# Discussion on Maintenance Comment 201 & 202

(<https://www.802-1.org/items/318> & 317)

# Comment 201 : 802.1Qbv Tick granularity

# Comment 202:

# Use Case with Different Tick Granularity

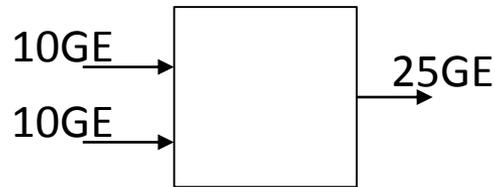
- Use case 1: aggregate flows from multiple port to one

- Tick granularity is only valid on egress port;
- Make TAS schedule for flow 1 & 2 according to TSpec

- Use case 2: schedule one flow over multiple device w/ different port rate

- Tick granularity are different on each device;
- Make TAS schedule on each egress port according to TSpec

No need to care common tick granularity for multiple port rate, and TAS schedule is based on PTP timing. It is not necessary to align with MII clocking.

# Comment 201 Discuss

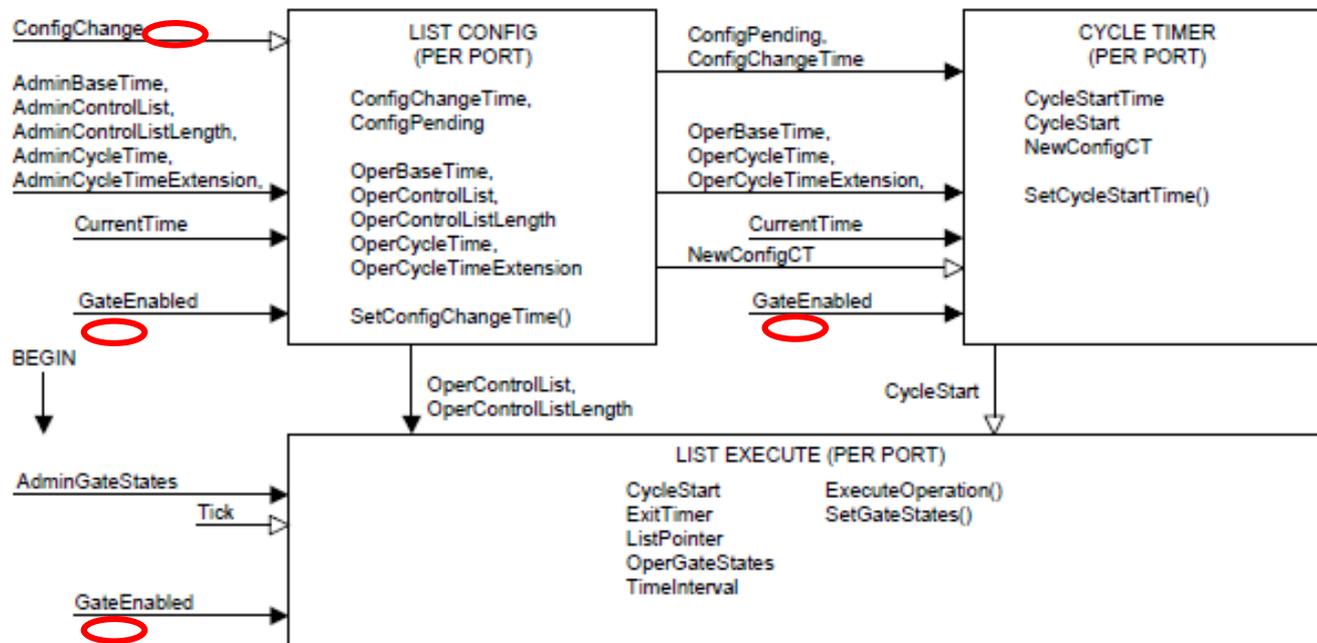
- Tick granularity is the capability of physical port, declaring minimal allocable time unit to the scheduling computation function block.
- Currently minimal allocable time/bandwidth unit is expressed by 0.1ns, which varies with port rate, from 1bit(GE) to 40bit(400GE).
- Shall we change minimal allocable time window from 0.1ns to 1e-x?
  - To make it align with physical MII interface clocking

Figure 8-16—List Config state machine

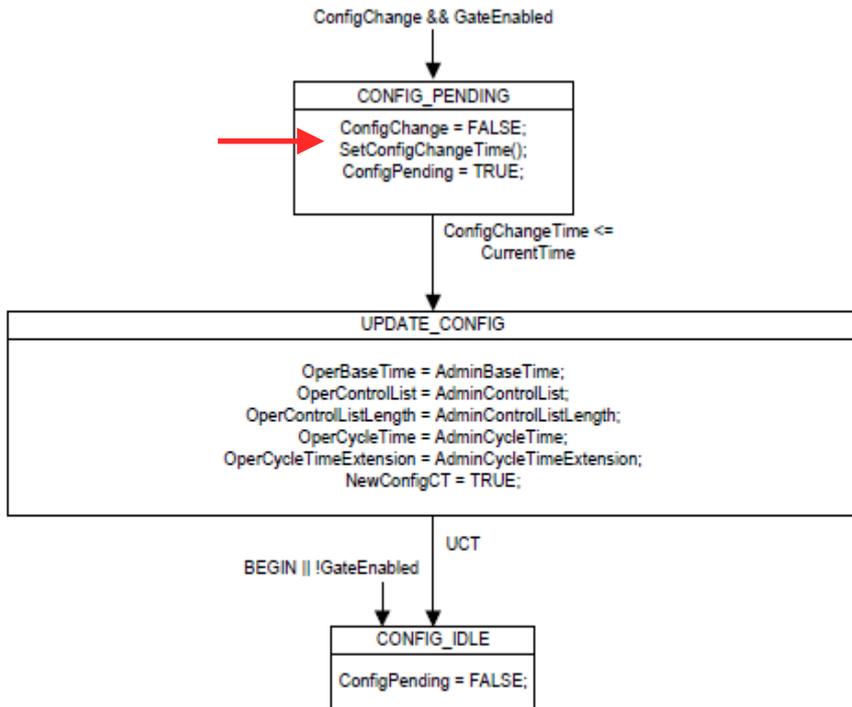
## Qbv ConfigChangeError counter incremented incorrectly

- GateEnable signal input to all three Qbv FSMs;

- This erroneous scenario happens only when changing configuration during runtime and AdminBaseTime is mistakenly set.
- Correct procedure for runtime reconfiguration to set Admin variables first and then activate ConfigChange trigger.
  - Ensure admin variables are set correctly to avoid configError warnings.
